Value Engineering Study Report

US 641 Connect Eddyville to Fredonia
Kentucky Transportation Cabinet (KYTC)
Item #1-187.31

Caldwell and Lyon Counties, Kentucky

VE RECOMMENDATION NO. 1: STRENGTHEN ACCESS CONTROL

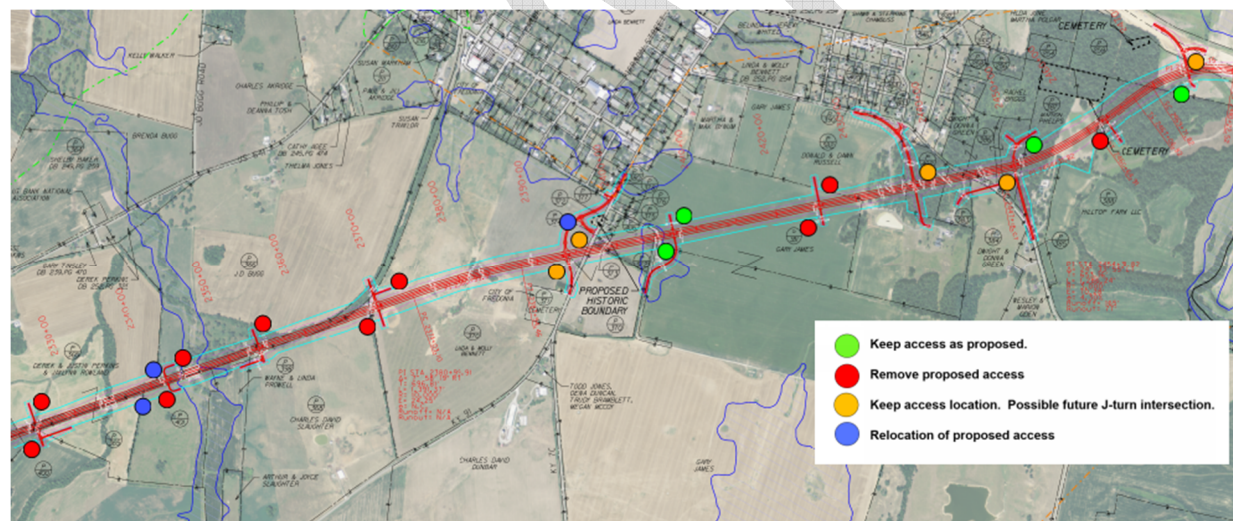
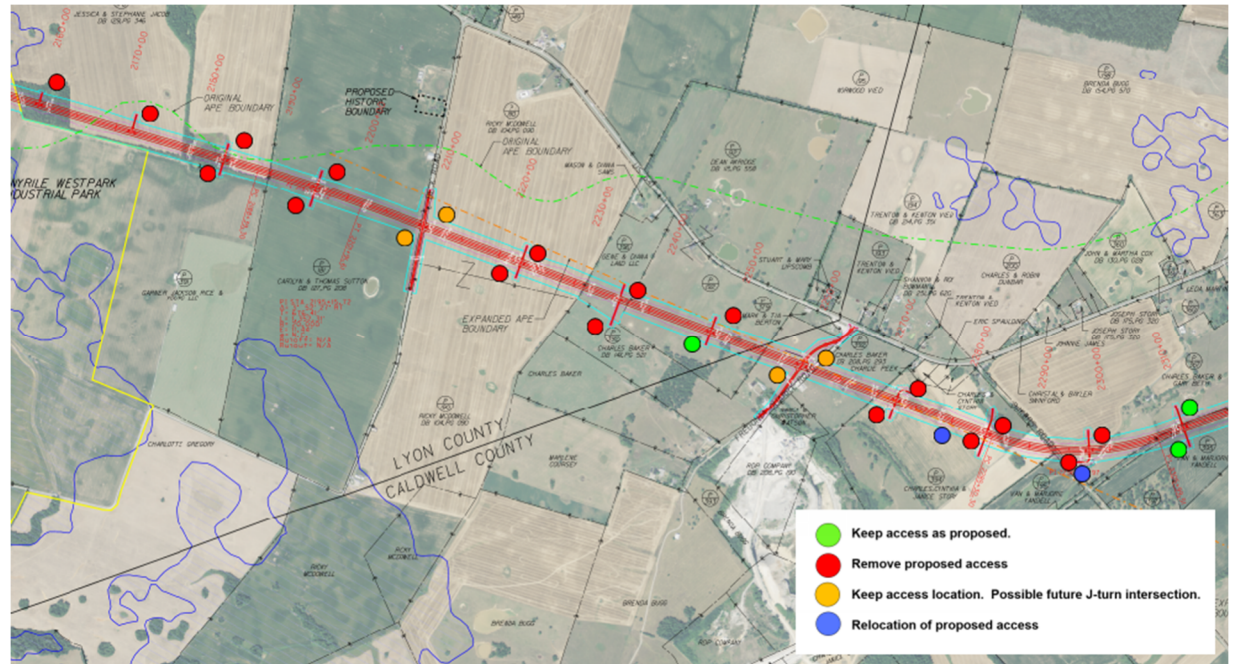
VE RECOMMENDATION NO. 1: STRENGTHEN ACCESS CONTROL		Idea Nos. 2, 10, 11		
Baseline Concept				
The project has been designed with access spacing and median openings at approximately 1,200 feet.				
Recommendation Concept				
Remove unnecessary access points and associated median openings throughout the corridor. Purchase access control for all frontage between the designed access points. Develop a corridor access management policy and agreement to be adopted by KYTC and local governments to support enforcement as permit requests are made in the future.				
Advantages		Disadvantages		
<ul style="list-style-type: none">• Reduces conflict points associated with intersections and entrances– locations with potential vehicle to vehicle crashes• Improves driver expectancy• Ensures safe freight mobility throughout the region.• Protects the mobility of the corridor far into the future• Allows for future development along existing public roads, including old US 641• Minor reduction in construction costs		<ul style="list-style-type: none">• New approach for design of access along a partially controlled corridor• May be a challenge for permitting staff to maintain access as specified in a corridor agreement.

VE RECOMMENDATION NO. 1: STRENGTHEN ACCESS CONTROL	Idea Nos. 2, 10, 11
Discussion/Sketches/Photos/Calculations	
<p>Technical Discussion/Sketches</p> <p>Research completed by the Kentucky Transportation Center for KYTC recommends necessary median openings and access points be separated by at least 2400' on high-speed rural arterials such as US 641. The purpose of this is to maintain the long-term mobility and safety of the corridors that connect cities and other destinations over long distances. Local access is meant to be achieved primarily from lower functional classification roadways.</p> <p>There are many opportunities to reduce the number of access points and median openings in the current design. The below sketches demonstrate potential changes. Locations recommended for removal from the design are marked in red (29). Those properties already have adequate access from either existing US 641 or other public roads or are duplicative along the proposed route. Those colored blue (5) are relocated from the current design. Those colored green (7) should remain to avoid land locking the adjacent property. Intersections along the route are recommended to remain with the caveat that significant increases in traffic or crashes at those locations may warrant conversion to a J-turn design.</p> <p>To avoid access points in the future due to subdivision of land, access rights should be purchased and a Memorandum of Understanding (MOU) between the local counties and KYTC should be developed. The MOU should identify as-built access locations, future acceptable locations (if any), and median opening/U-turn locations. Agreements of this nature which have been implemented on other corridors in Kentucky can serve as a model for US641.</p> <p>This recommendation is primarily to preserve the mobility and safety of the corridor. However, there are cost savings nearing \$1 million from the removal of so many entrances.</p>

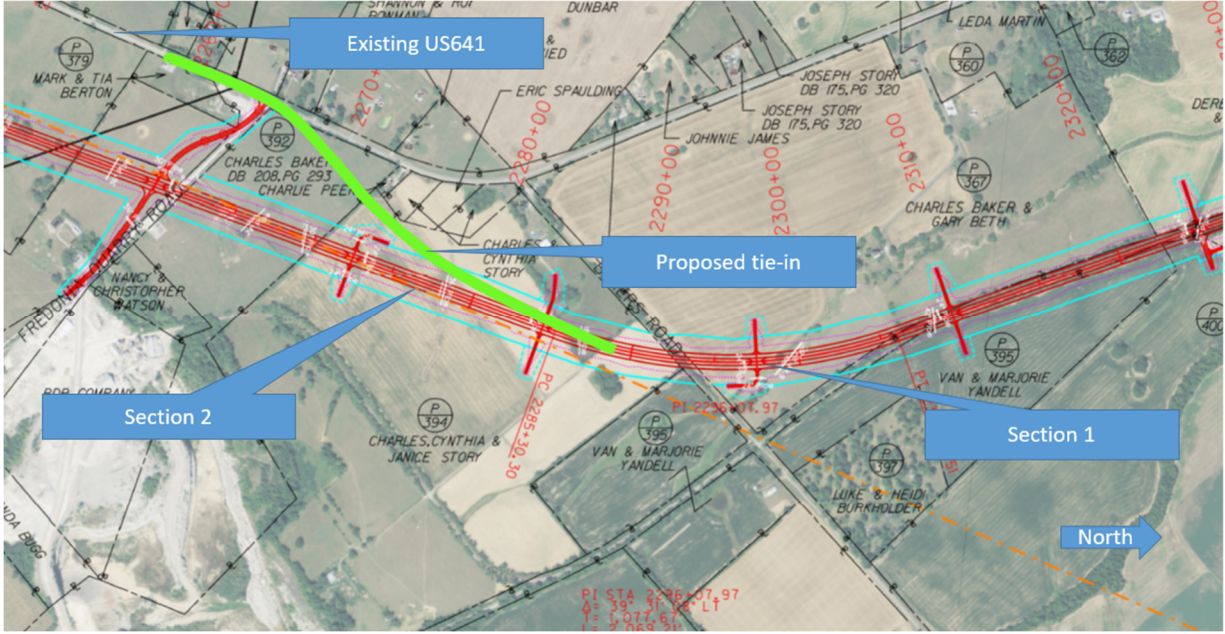
VE RECOMMENDATION NO. 2: DESIGN FOR TWO CONSTRUCTION SECTIONS		Idea No. 3		
Baseline Concept				
The current design is prepared as a single, stand-alone construction project.				
Recommendation Concept				
Divide the design into two construction sections with a temporary tie-in to existing alignment south of Bakers Road. Build the northern section first.				
Advantages		Disadvantages		
<ul style="list-style-type: none">• Likely to receive construction funding sooner if segmented• Addresses highest freight mobility need by removing trucks from Fredonia• Potential cost savings associated with avoiding escalation		<ul style="list-style-type: none">• Risk of tie-in section to existing US 641 to be short lived.		
Cost Summary		Construction	Right-of-Way	Total
Baseline Concept				
Recommendation Concept				
Added Cost		\$0.67M		\$0.67M
FHWA Function Benefit				
Safety	Operations	Environment	Construction	Right-of-Way

VE RECOMMENDATION NO. 2: DESIGN FOR TWO CONSTRUCTION SECTIONS	Idea No. 3
Discussion/Sketches/Photos/Calculations	
<p>Technical Discussion/Sketches</p> <p>This proposal is to divide the project into two construction sections, the first of which can be operational upon completion. Because this is such a large project requiring over \$50 million in funding to complete (the initial 2-lane phase), it is unlikely to receive all the funding it needs in the next several highway plan cycles. Splitting into smaller sections with logical termini will increase the likelihood of advancing the project to phases beyond design and getting construction underway.</p> <p>The project is broken into two projects in the current highway plan. However, the division is identified at Beck Road, a location on the corridor that does not facilitate a quality temporary tie-in to the existing route.</p> <p>A logical location to make the division is just south of Bakers Road, where the existing and proposed alignments are at their closest proximity. There are options on precisely how to align the tie-in that will connect the two routes. One option is presented below. It is assumed that the new corridor would be built with an initial two-lane roadway, so no lane drop or lane add would be needed in the tie-in.</p>  <p>Building Section 1 (3.8 miles), the northern section, first will facilitate the removal of truck traffic through Fredonia and improve the freight travel time for the corridor, thus supporting a key piece of the project's purpose. Section 2 (5.4 miles) would be advanced in the future to complete the connection to US 62 near the I-69 interchange.</p> <p>It is recommended to advance right-of-way acquisition and utility relocations for Section 1 and the tie-in first in order to expedite the construction of that section. Right-of-way acquisition and utility relocations for Section 2 should begin after the construction contract for Section 1 is let.</p> <p>Because it is unknown how long it will be between the opening of traffic on Section 1 and completion of Section 2, there is some risk to this approach. Should Section 2 advance quickly, the life of the tie-in would be short lived, thus reducing the benefit to cost ratio. However, it is also a distinct possibility that the time between each could be significant.</p>

VE RECOMMENDATION NO. 3: OPTIMIZE PROFILE TO PROMOTE EARTHWORK BALANCE

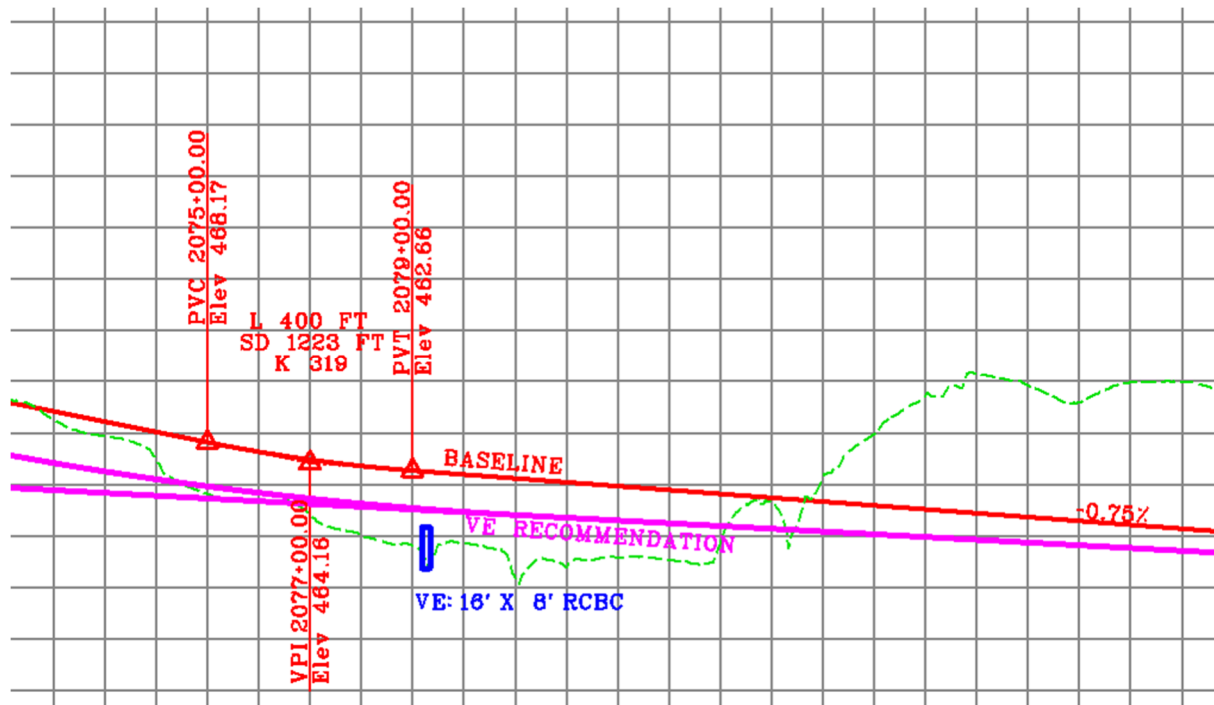
Due to the relatively high cost of embankment in place in the baseline Preliminary Line & Grade (PL&G) estimate, the VE team evaluated the baseline profile along with design assumptions to determine if optimizing the profile could better balance the earthwork needed.

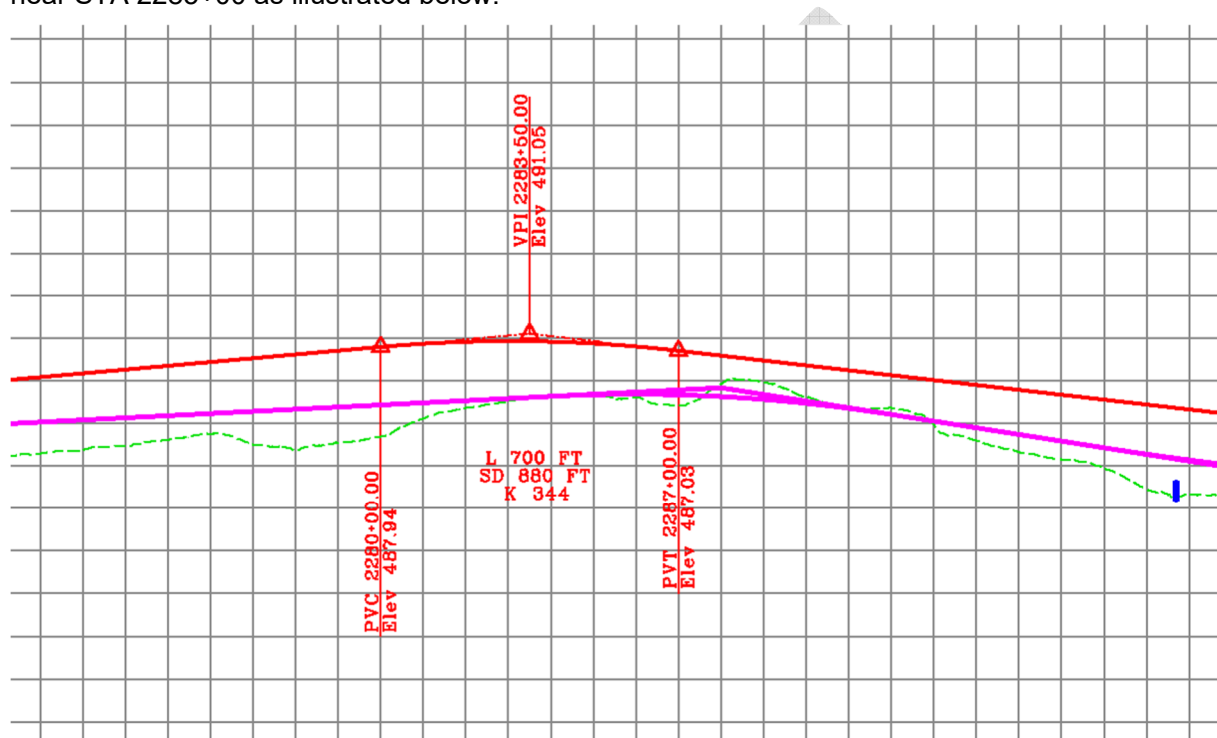
Another location that we were able to lower slightly was near the stream crossing at STA 2148+00. Although the bridge hydraulic analysis determined that the span arrangement needed to be lengthened, it also allowed for a profile grade of approximately 417.65.

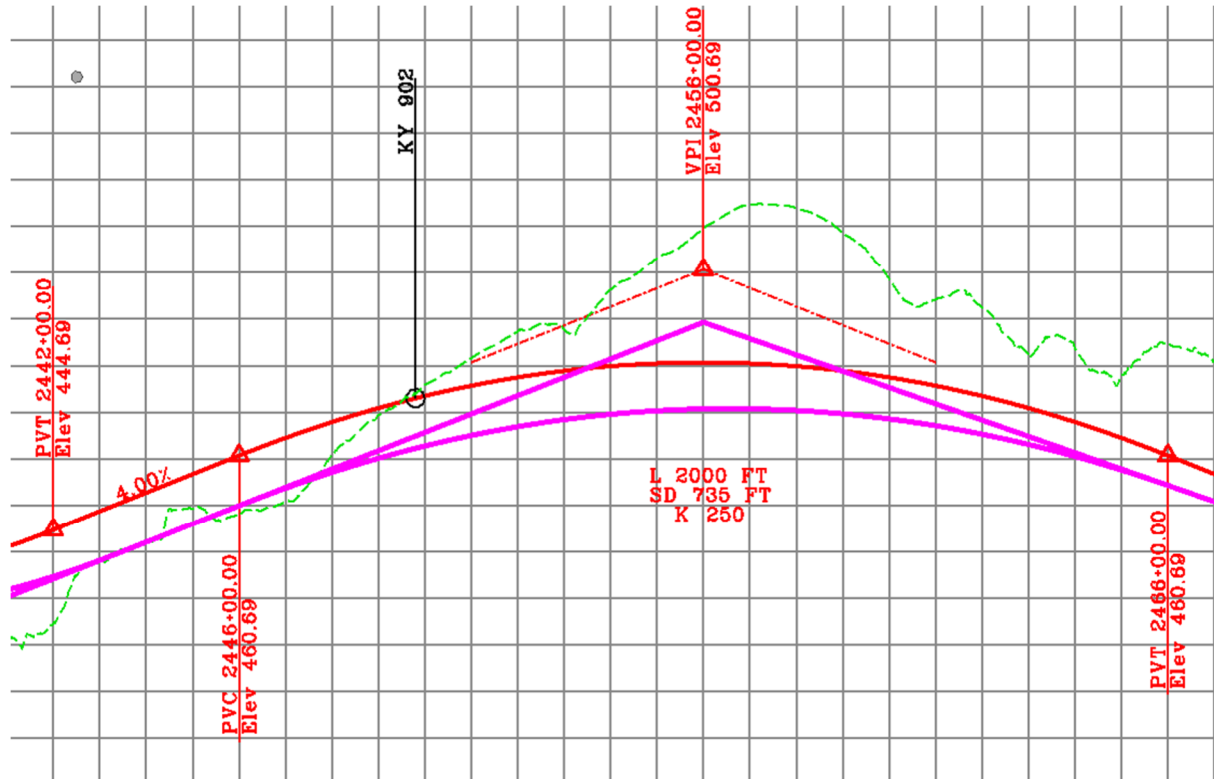
Several crest locations were adjusted lower where constraints allowed. One example location is near STA 2285+00 as illustrated below:

Near the end of the project, the profile was adjusted lower significantly while considering the road approach tie-ins with KY 902. The required maintenance of traffic will require further consideration as the project progresses through Phase 2 design as this provides an excellent source of raw material within the baseline right of way limits.

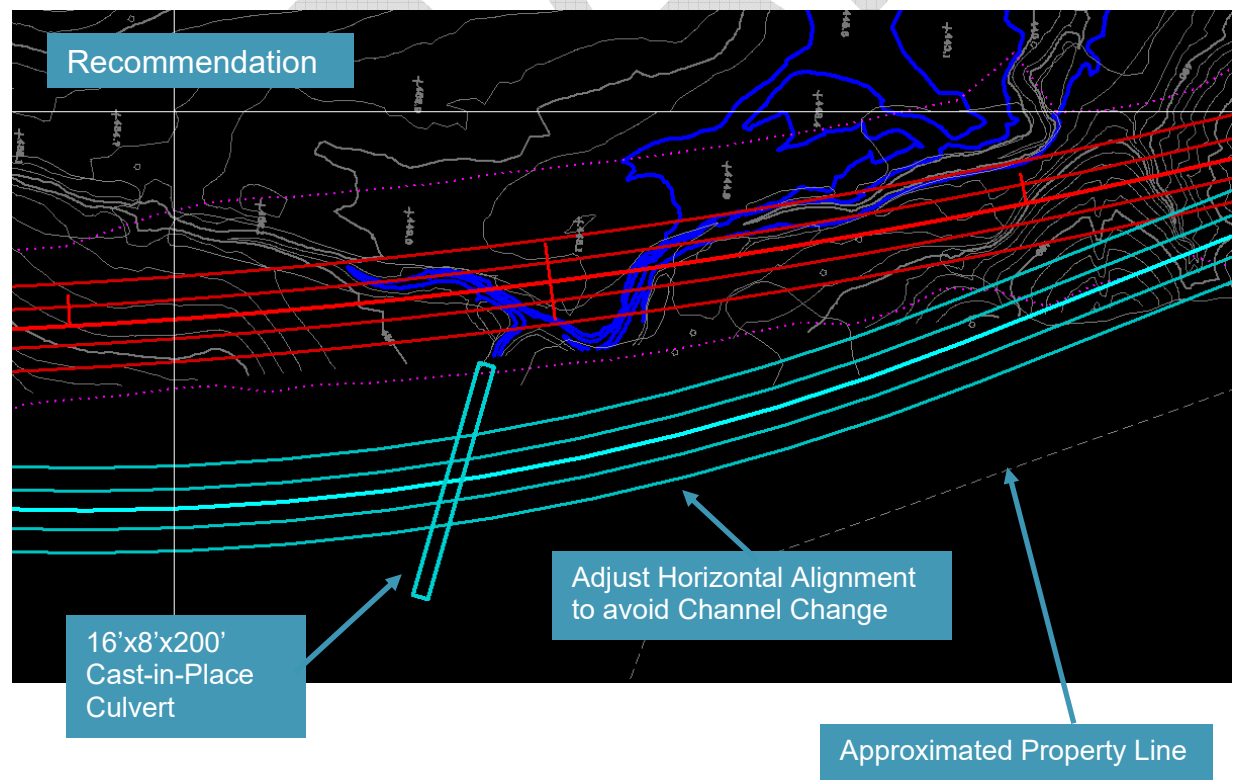
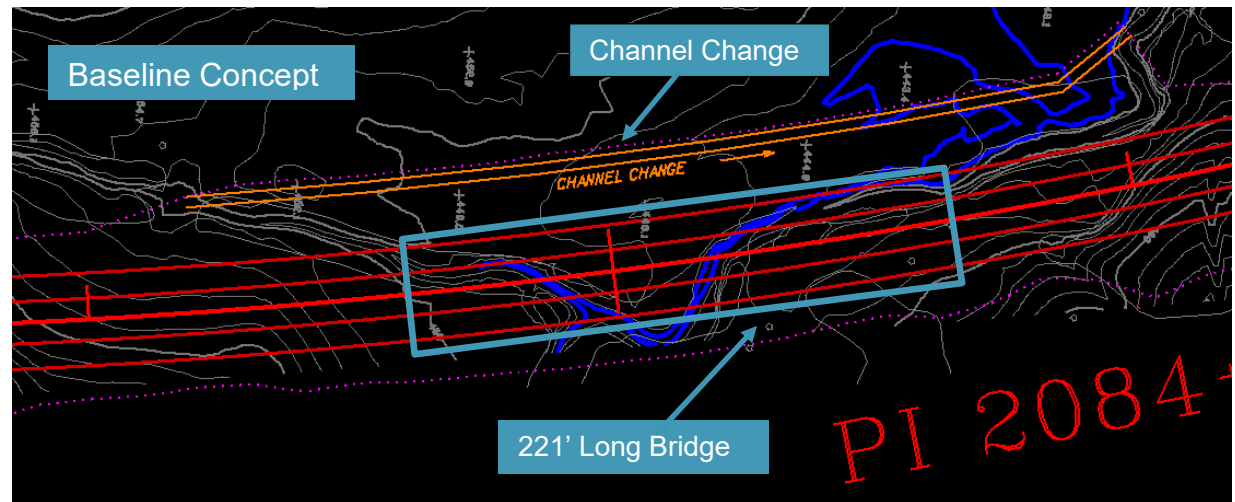
Recommendation Concept		
<p>The VE team reviewed preliminary layouts for the structures and recommend changes to the following three structures:</p> <p>Structure #1 Recommendation</p> <ul style="list-style-type: none"> • Modify alignment to avoid channel change and use a cast-in-place box culvert • The alignment modification can be accomplished by taking additional right-of-way from the property west of the Western Kentucky Correctional Facility and avoiding additional impacts to the correctional facility • Size = 16ft x 8ft x 200ft <p>Structure #2 Design Consideration</p> <ul style="list-style-type: none"> • The baseline concept may increase high water elevations which may result in the need for a Conditional Letter of Map Revision (CLOMR). An item to consider as design advances would be to evaluate the drainage opening requirements and consider limiting the rise to no more than 1.0 foot. This may result in the structure increasing in length that is close to 500 feet. <p>Structure #3 Recommendation</p> <ul style="list-style-type: none"> • Use a cast-in-place box culvert • Size = 16ft x 8ft x 200ft

VE RECOMMENDATION NO. 4: MODIFY STRUCTURES 1, 2, & 3		Idea Nos. 13, 16, 17		
<ul style="list-style-type: none">• Eliminates channel change construction and associated in-lieu fees• Reduces potential for project delays due to environmental impacts				
Structure #3 <ul style="list-style-type: none">• Decreases construction cost• Decreases future maintenance cost• May decrease construction schedule		Structure #3 <ul style="list-style-type: none">• May cause adverse impacts to properties• May cause adverse impacts to proposed horizontal and vertical geometry		
Cost Summary		Construction		Total
Baseline Concept	\$9.17M			
Recommendation Concept	\$6.70M			
Cost Avoidance	\$2.47M + 31.5% markup =		\$3.25M	
FHWA Function Benefit				
Safety	Operations	Environment	Construction	Right-of-Way
		✓

US 641 Drainage Profile at Structure #2

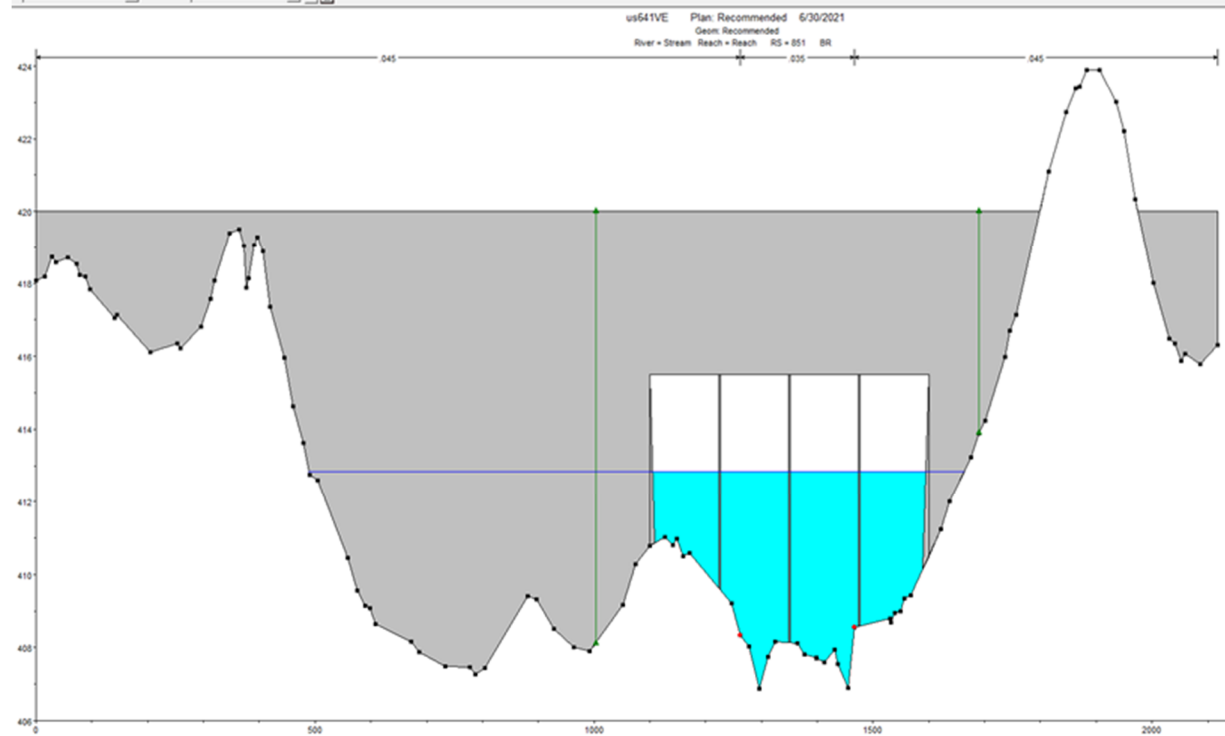
Structure #2 – Design Consideration

Reach	1009.009	PF 1	Existing	8410.00	412.15
Reach	1009.009	PF 1	Baseline Concept	8410.00	417.03
Reach	1009.009	PF 1	Recommended	8410.00	413.14
